Accessibility Survey

City of Downey Lakewood Boulevard & Columbia Way

Date of Inspection
5/25/2017

Disability Access Consultants

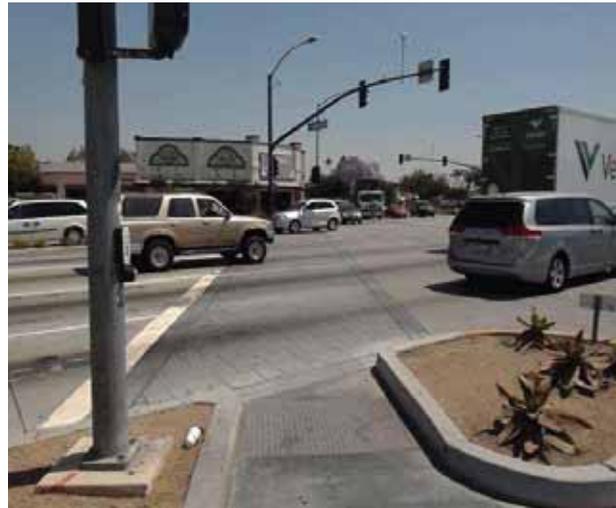
No tactile arrow provided for the signal.

On-Site Finding Not Found

Provide a compliant tactile arrow at the signal.

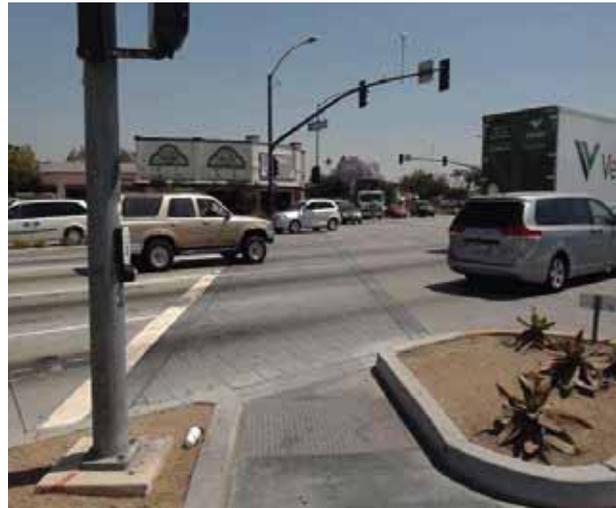
Either universal tactile or universal symbol is not provided at the signal.

On-Site Finding Not Found

Universal tactile and universal symbol must be provided at the signal (3 braille dots forming an equilateral triangle).

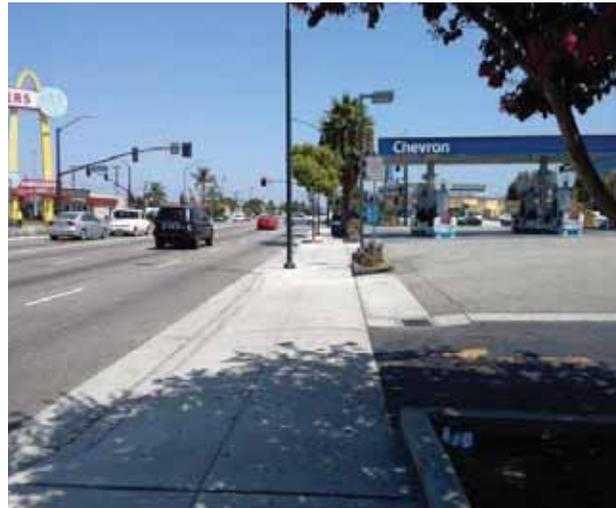
There are no detectable warnings where the pedestrian route crosses vehicular traffic.

On-Site Finding Not Found

Provide detectable warnings.

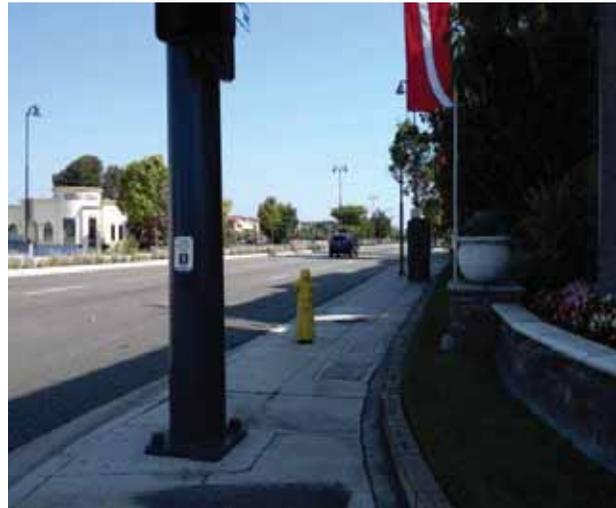
Sidewalk cross slope is not compliant.

On-Site Finding 3.40 percent for 35.00 feet

Repave the sidewalk surface with the recommended cross slope.

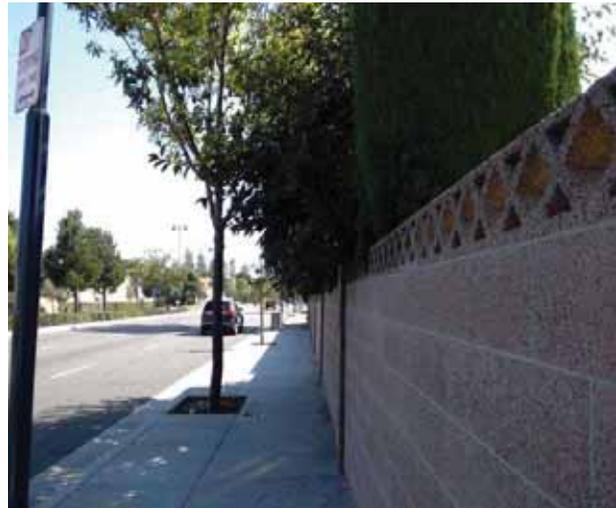
Overhead obstruction height is not compliant.

On-Site Finding 60.00 inches

Provide a compliant vertical clearance height.

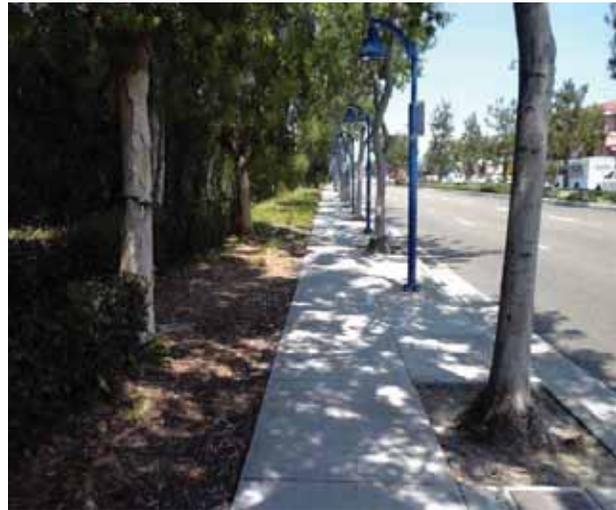
Sidewalk does not have enough width.

On-Site Finding 47.00 inches for 5.00 feet

Widen the sidewalk to the recommended value.

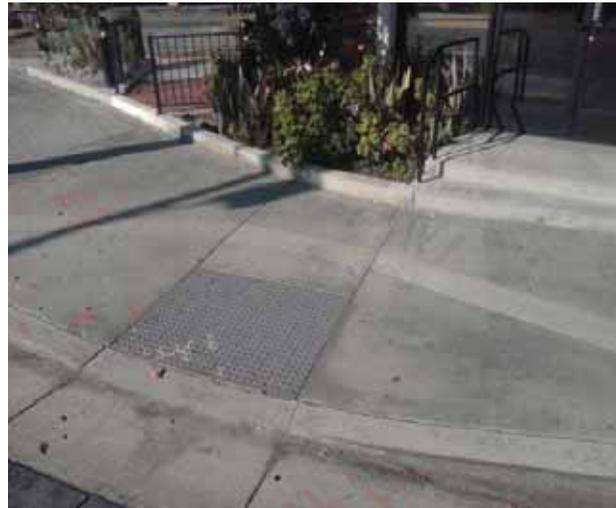
The slope at the top landing is greater than allowed.

On-Site Finding 8.30 percent

Provide a top landing surface that does not exceed the maximum slope and cross slope. Provide a sufficient maneuvering clearance that does not accumulate water.

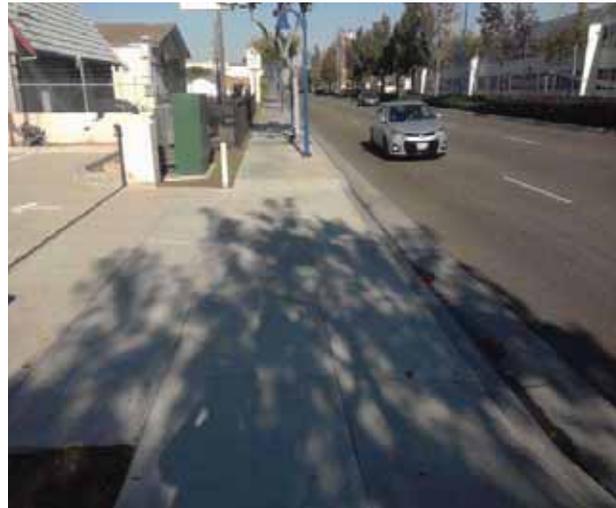
There are no detectable warnings where the pedestrian route crosses vehicular traffic.

On-Site Finding Not Found

Provide detectable warnings.
